**SAN ANTONIO WATER SYSTEM
DOS RIOS WRC FIRST STAGE DIFFUSER REPLACEMENT
SAWS Job No. 13-6502
SAWS Solicitation No. B-13-075-MF**

**ADDENDUM No. 1
November 11, 2013**

C2
SHT 6 of 10

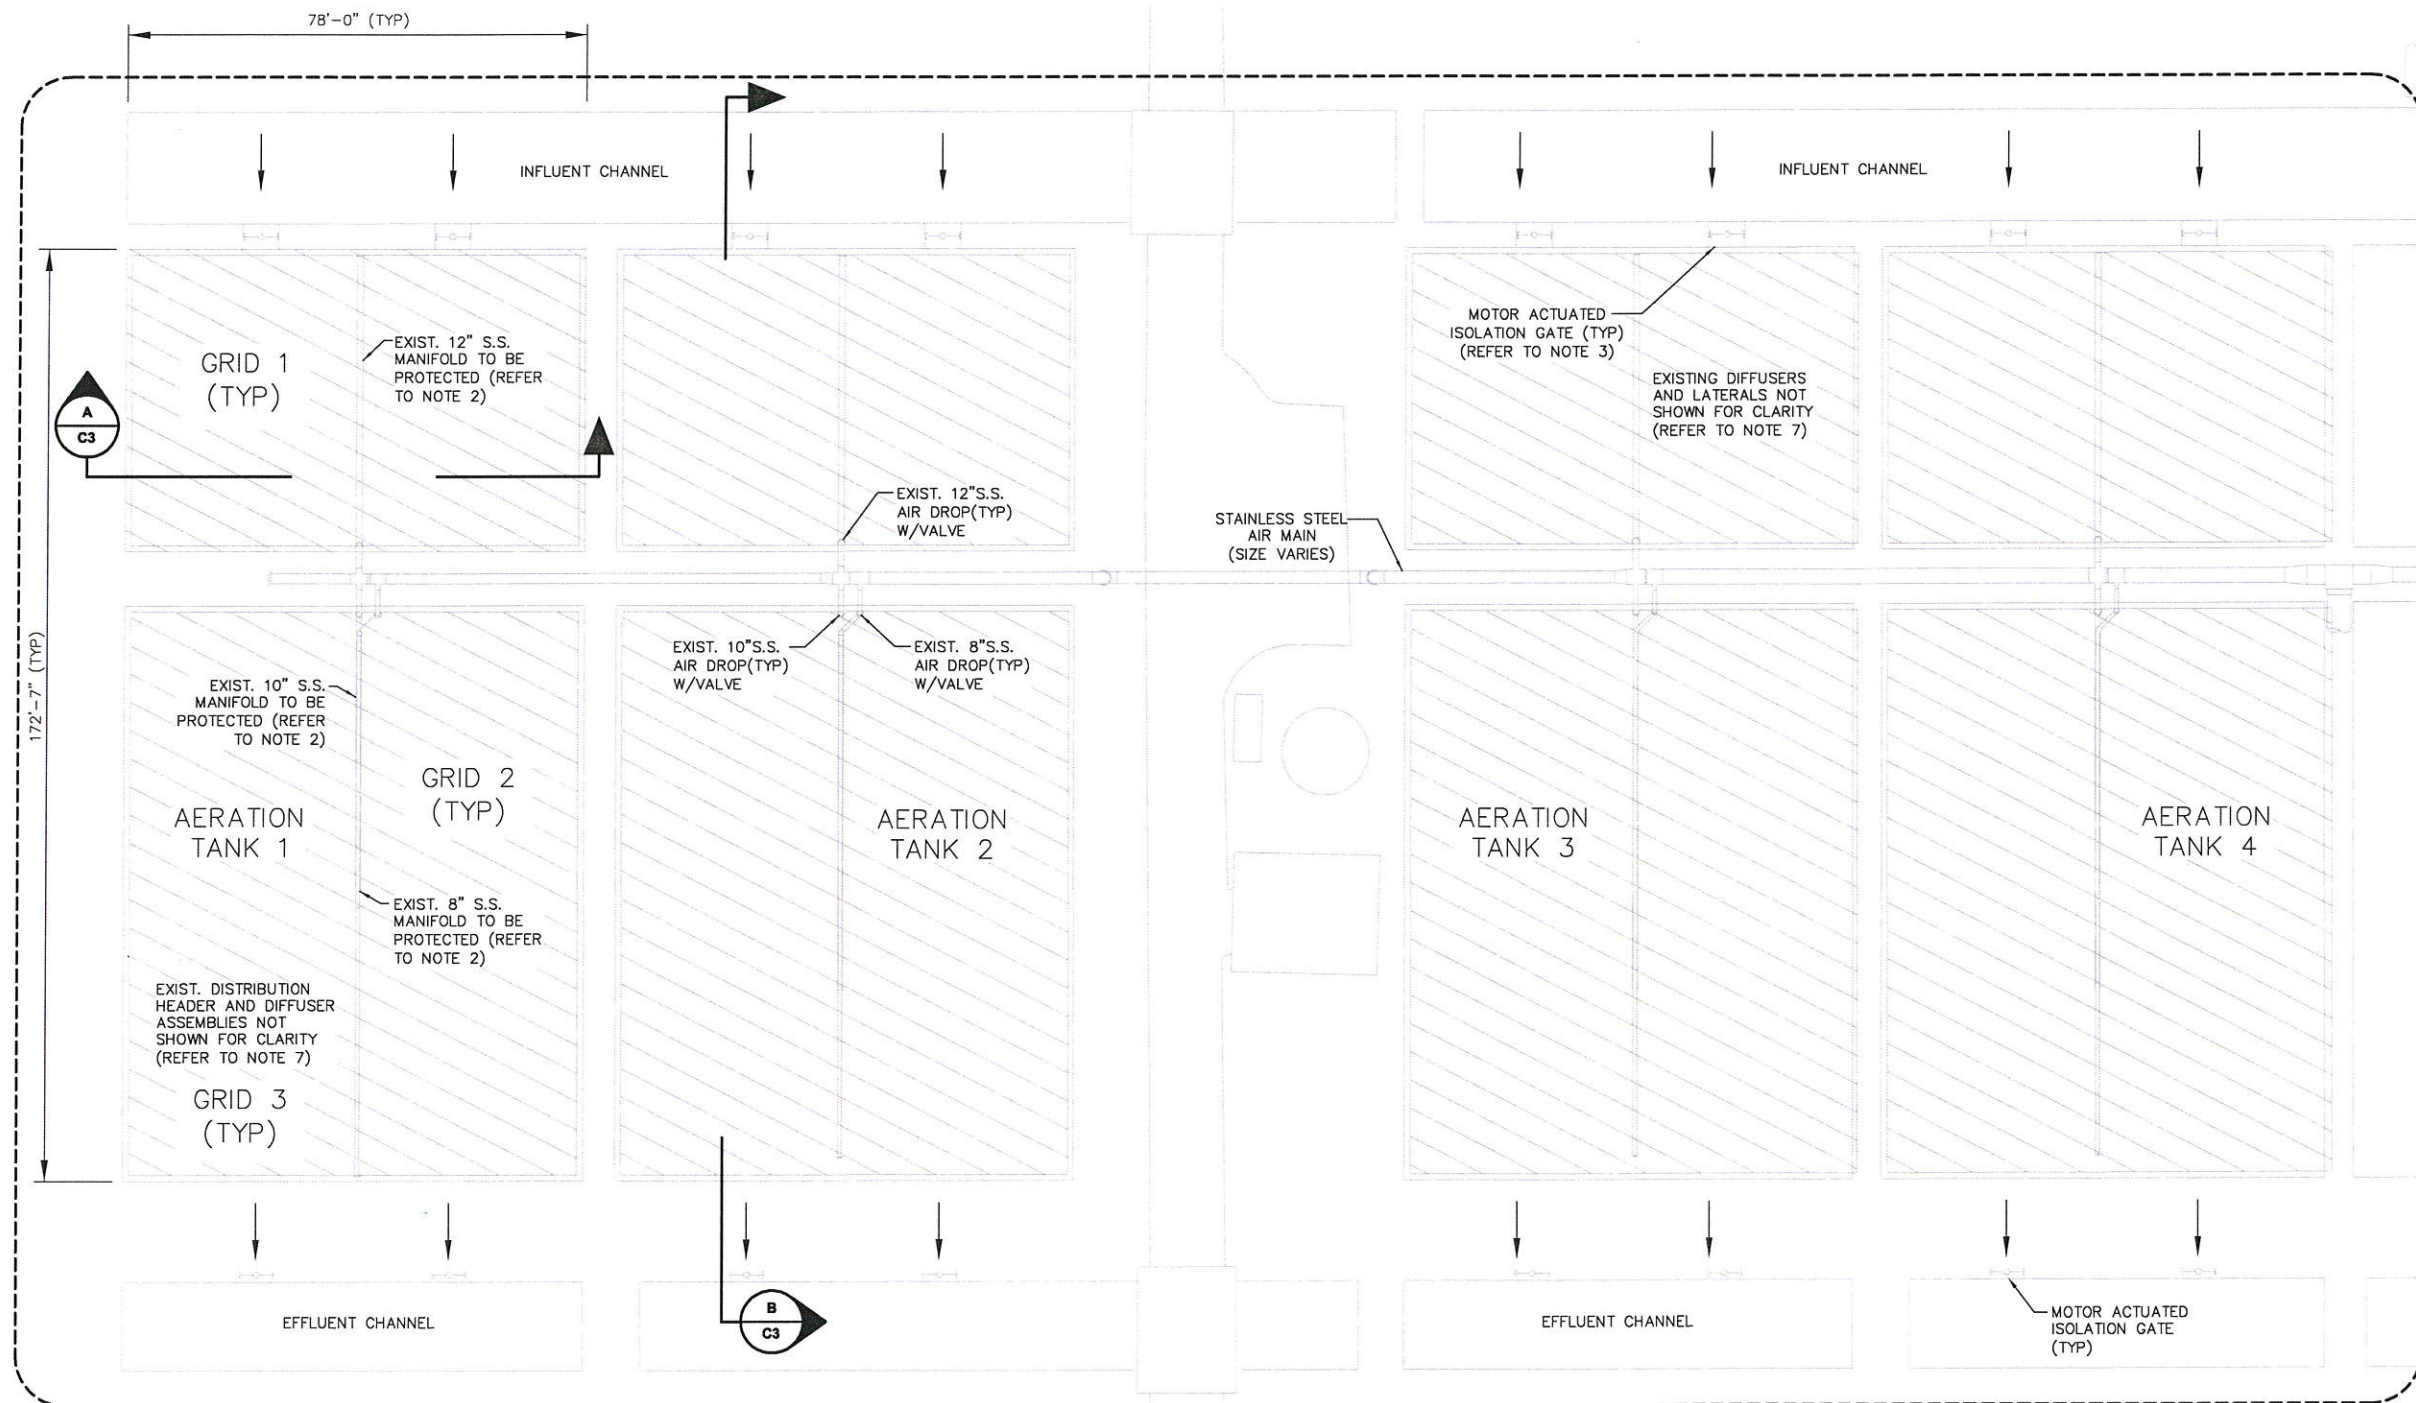
1. Sheet C2, REMOVE and REPLACE Note 6 as follows:

“6. Protect and maintain all existing stainless steel purge lines in all ten (10) basins. Reconnect all existing stainless steel purge lines to new diffuser system. Connection shall be made in accordance with manufacturer’s recommendation.”

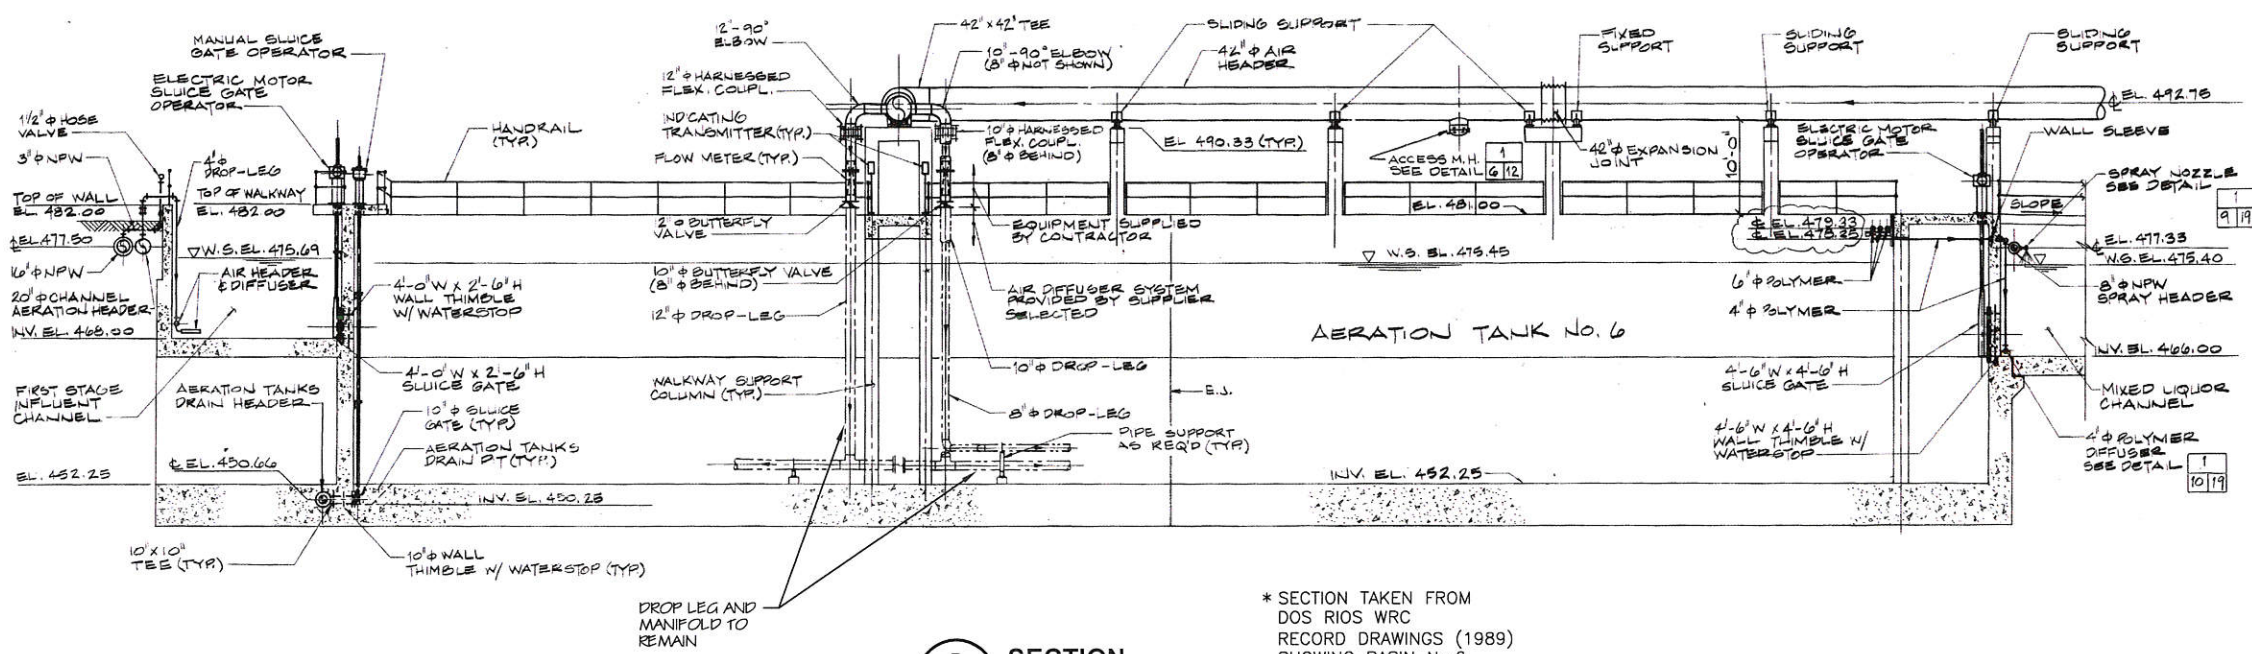
2. Sheet C3, REMOVE and REPLACE Note 1 as follows:

3. Sheet C3, REMOVE and REPLACE Note 3 as follows:

4. Sheet C3, REMOVE and REPLACE Note 4 as follows:

“1. Owner shall assist in draining each basin. Assistance is limited to operating existing drain valve(s) which drain basin(s) to plant drain system. SAWS will also put a trash pump in each basin to assist with draining.”

“3. Protect and reuse existing stainless steel manifold and purge lines.”

“4. Remove and dispose of all PVC Air Distribution Header, Ceramic diffuser assemblies, and piping supports. Contractor shall minimize damage to basin floor. Cut existing diffuser supports at base.”

DEMOLITION PLAN
(SHEET 2 OF 3)

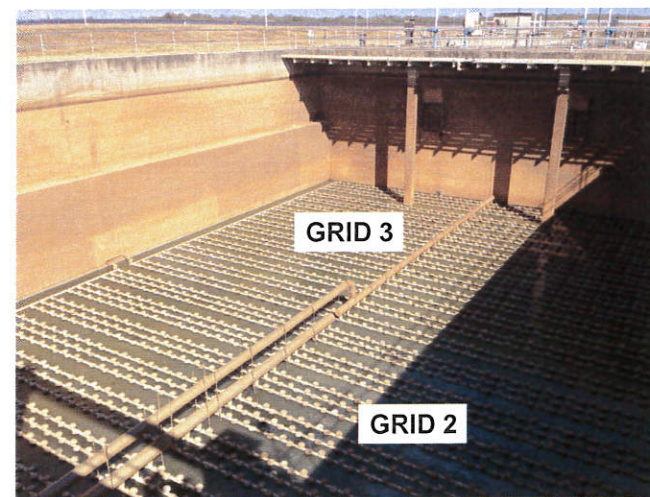
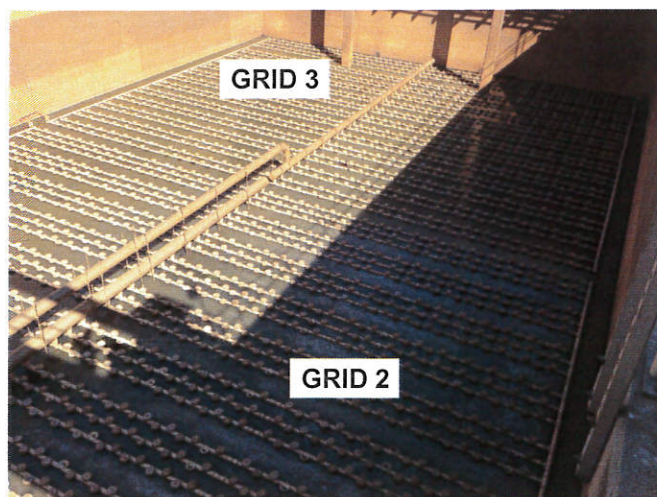
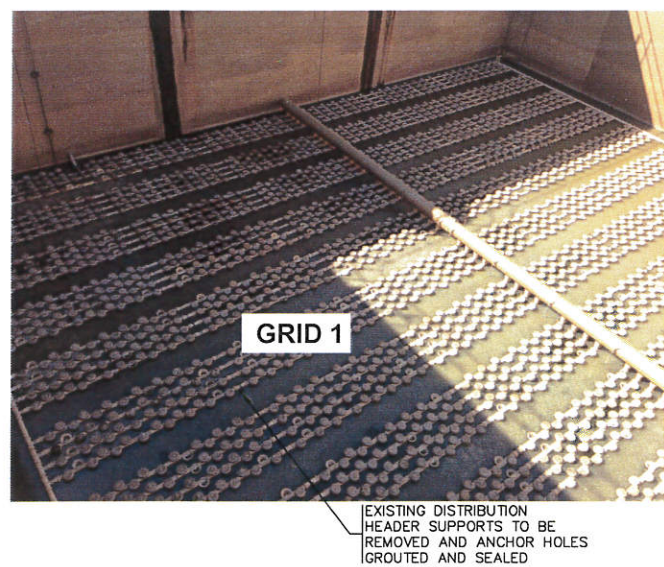
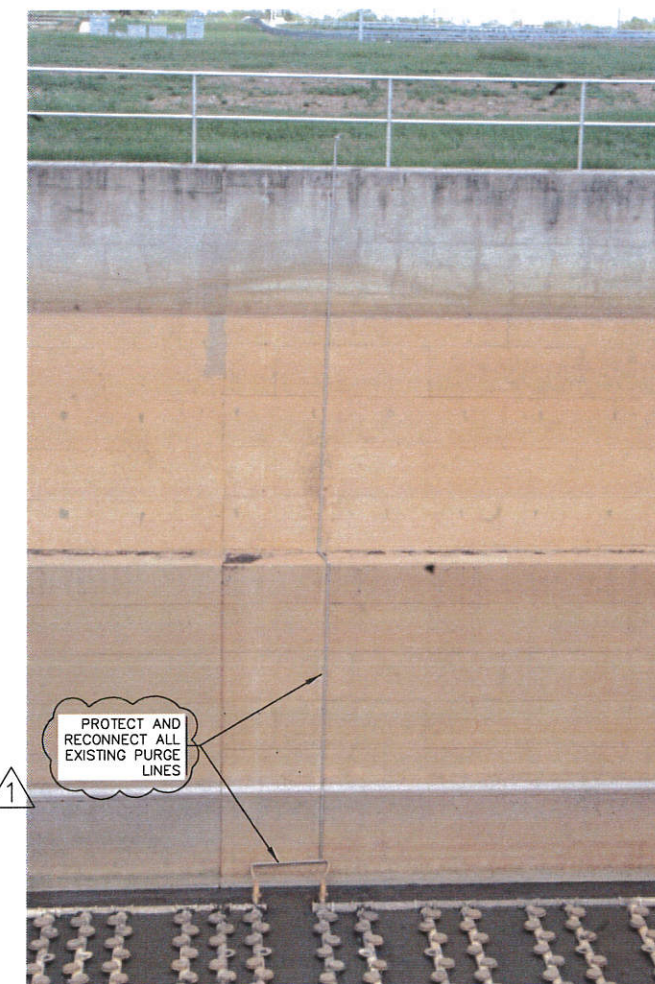
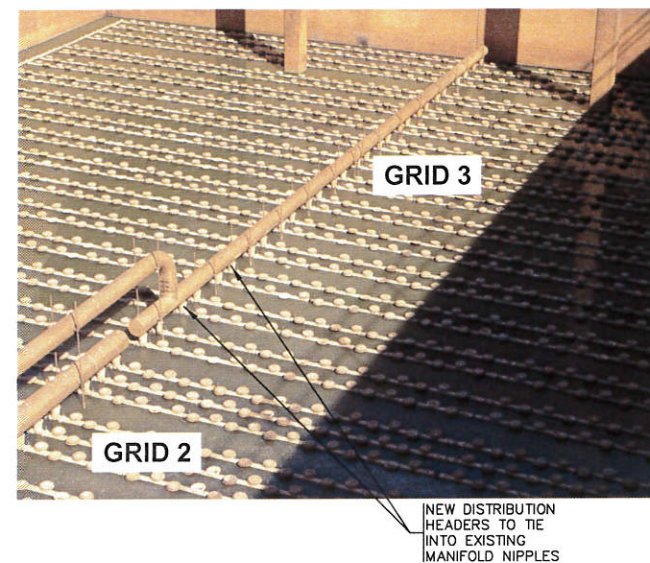
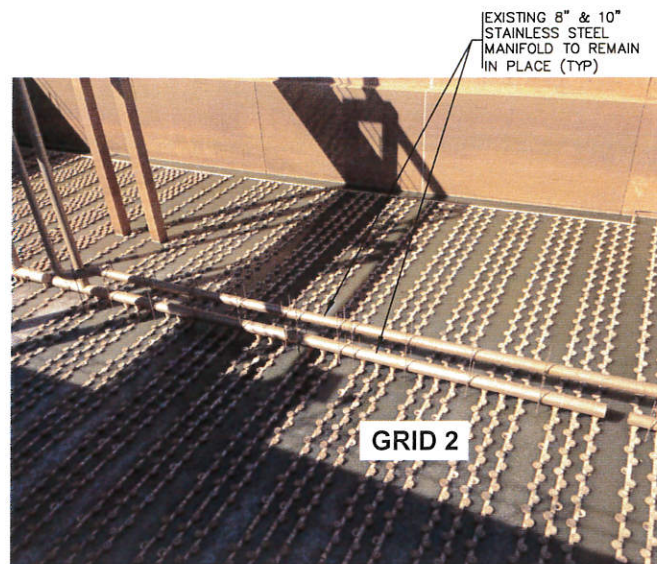
5. Sheet C4, REMOVE and REPLACE Note related to the diffuser system purge lines.

“Protect and reconnect all existing purge lines.”

DIFFUSER LAYOUT PLAN BASIN NO. 1 (TYP*)
SCALE: 1/8"=1'-0"

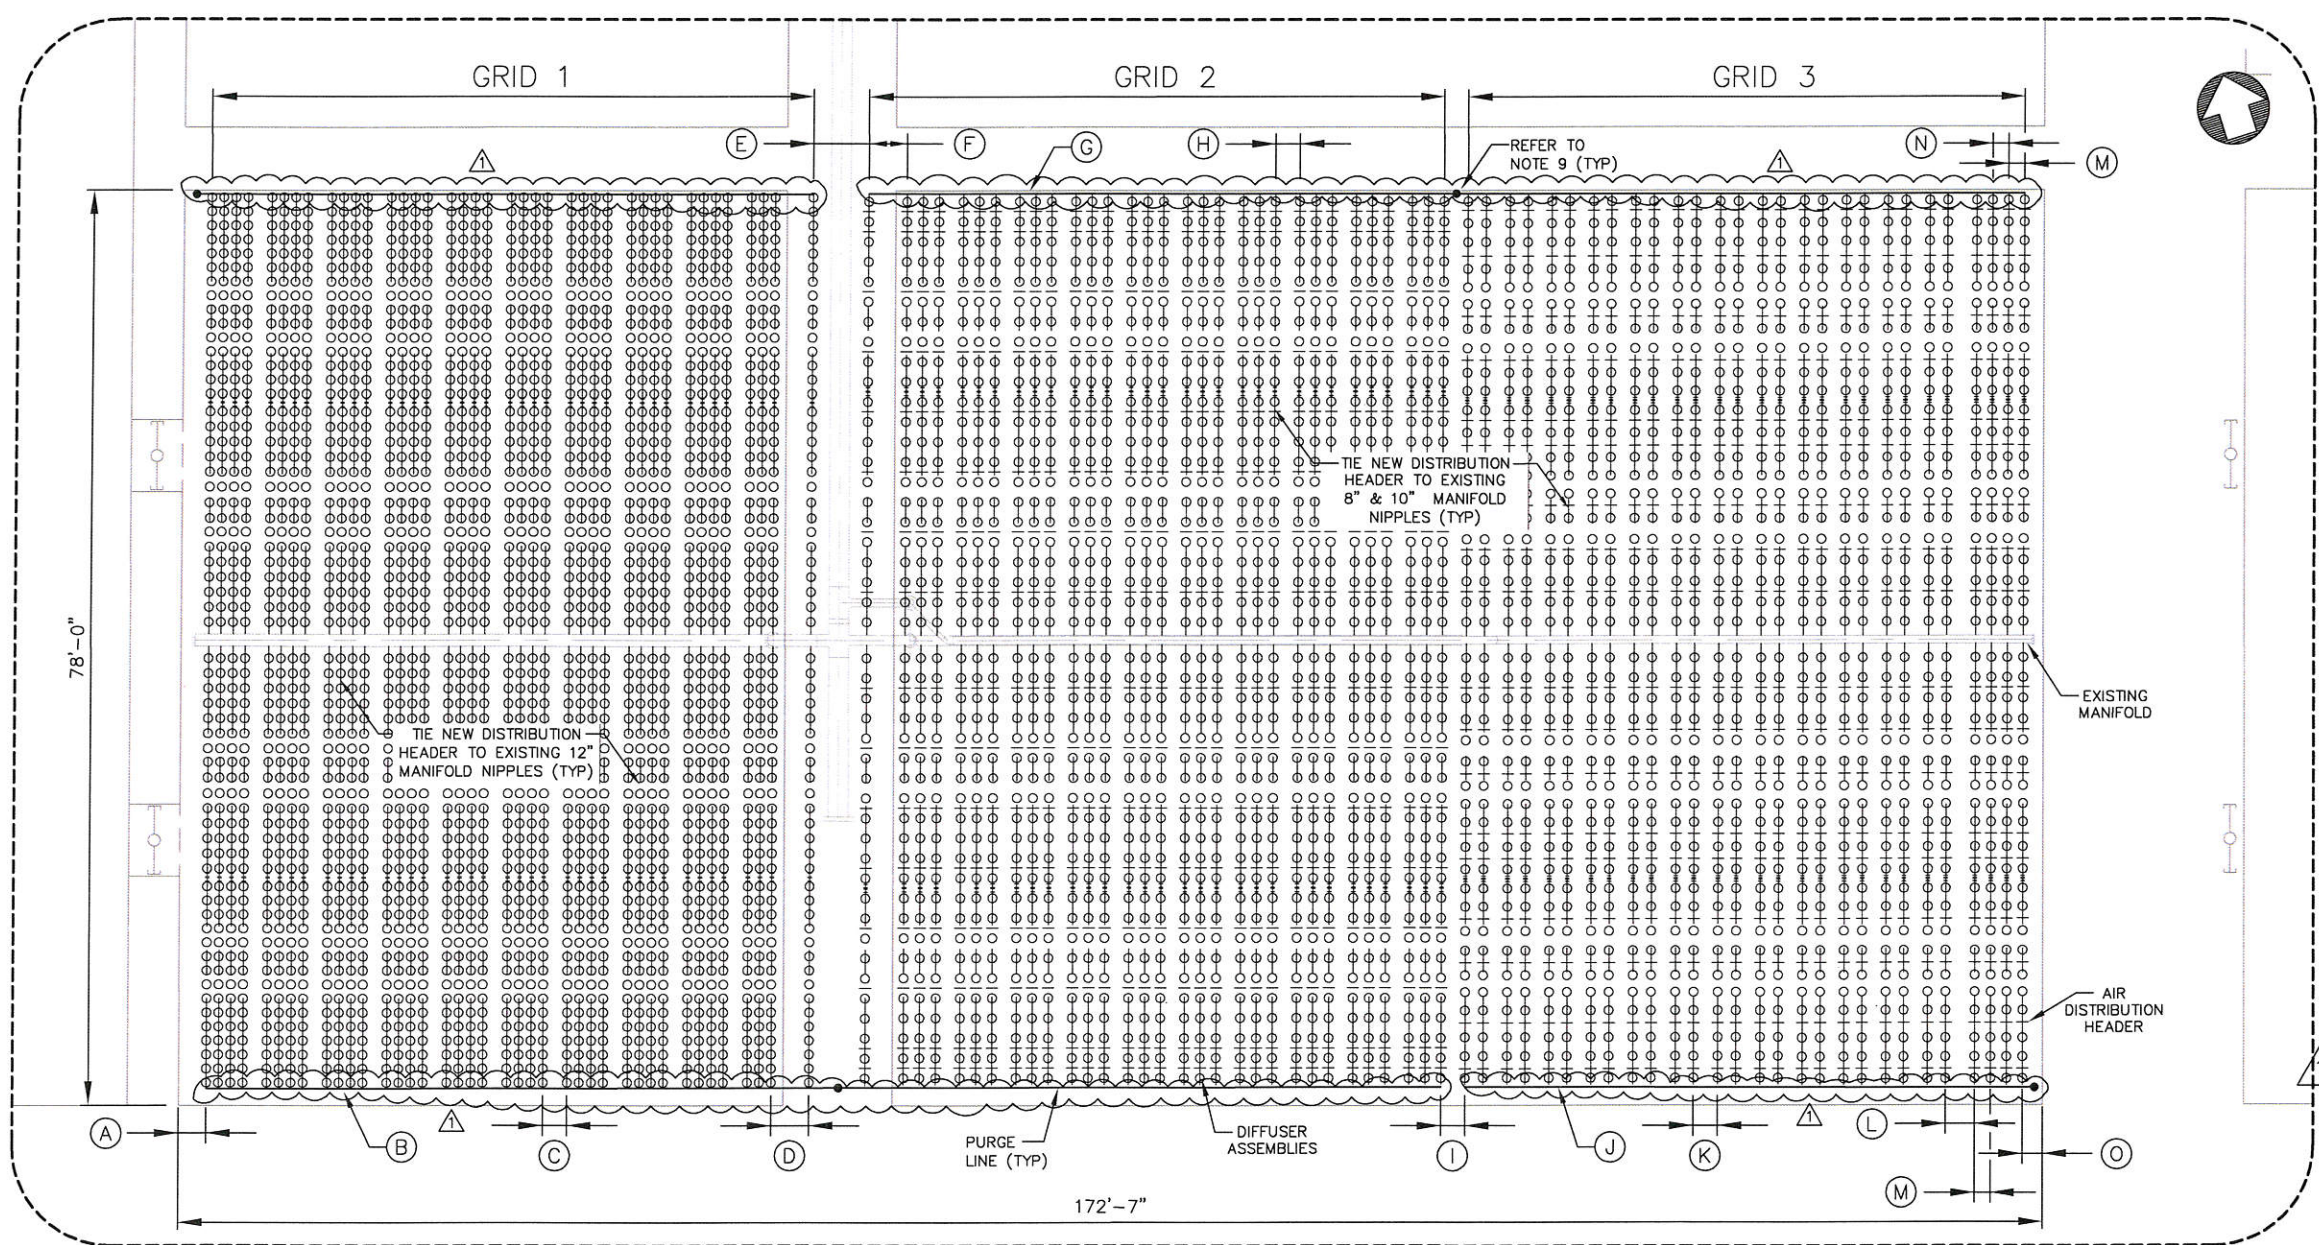
6. Sheet M1, Drawing was revised to show required manifold drainline(s) and add Note 9.

“9. The purge system shall match the existing grid configuration. A manifold (drainline) connects all headers along the extreme ends of the Grid System. Four purge lines are provided per basin and these lines are interconnected as follows:

- Grid No. 2 and 3 are interconnected to a single purge line on the north end of the basin.
- Grid No. 1 and 2 are interconnected to a single purge line on the south end of the basin.
- Grid 1 is connected to a single purge line on the north end.
- Grid 3 is connected to a single purge line on the south end.

Field verification is required to match the existing system design. The stainless steel purge main from the bottom of the basin to the top of the structure shall be re-used. The existing valve shall also be reused. Provide the manifold (drainline) that interconnects the ends of the headers.”
